# Service Bulletin

**SP-030**

DATE: November 17, 2010  
 TO: All Service and Parts Managers  
 SUBJECT: GPH13 Internal Wiring Issue

**Figure 1**

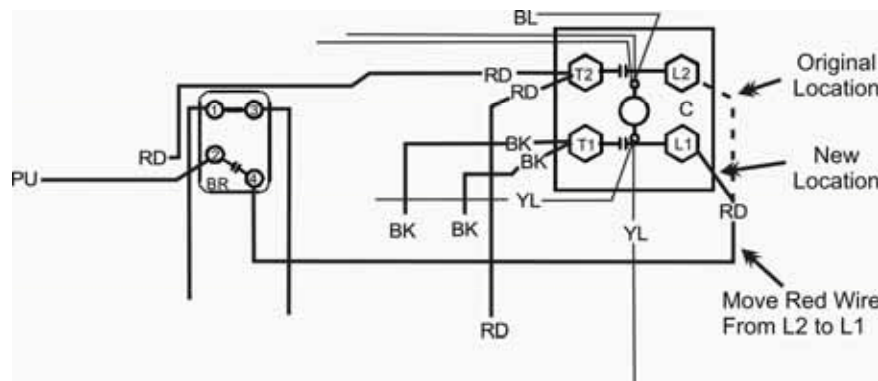
After investigation it has been determined that there is an issue with the wiring in some GPH13 model package units built from September 1, 2010 (serial prefix 1009) to November 2, 2010 (serial prefix 1011) that have HKR heater kits installed. The issue is only on models listed below which are equipped with a PSC type indoor blower motor. The red wire from terminal 4 of the Blower Interlock Relay (BR on wiring diagram) is connected to L2 on the contactor (C on the wiring diagram) but should be connected to L1 on the contactor (See Figure 1). Under certain conditions, this could cause a failure of the relay on the PCBFM131 Blower Control Board (EBTDR on the wiring diagram) by welding the Normally Closed contacts closed.

The wiring diagram on the unit and in the literature also shows the red wire connected to L2 on the contactor but should be connected to L1 on the contactor. The affected models are listed in the charts below.

All affected units in Goodman's inventory have been put on hold and are being reworked by moving the red wire from L2 to L1 on the contactor and installing an updated wiring diagram. These units can be identified by a tan dot on the traveler label.

Distributors should check their inventory for the models listed in the charts on the previous page and put on hold until they are reworked by moving the red wire from L2 to L1 and installing an updated wiring diagram (Part # 0140G01745). The diagram can be ordered from Service Parts by contacting your Customer Service Representative.
